Environmental Compliance and Management Systems Audit

Fort Knox and True North Mines

SRK Consulting (U.S.), Inc.

May 2012

True North Waste Rock Dump Slump

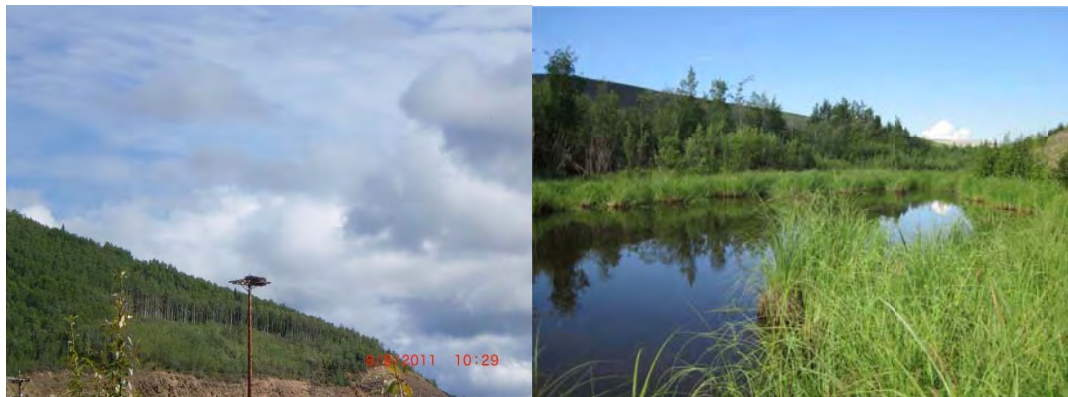
See Section 4.1.3, Reclamation and Closure, for discussion and recommendations to mitigate the True North waste rock dump slumps.
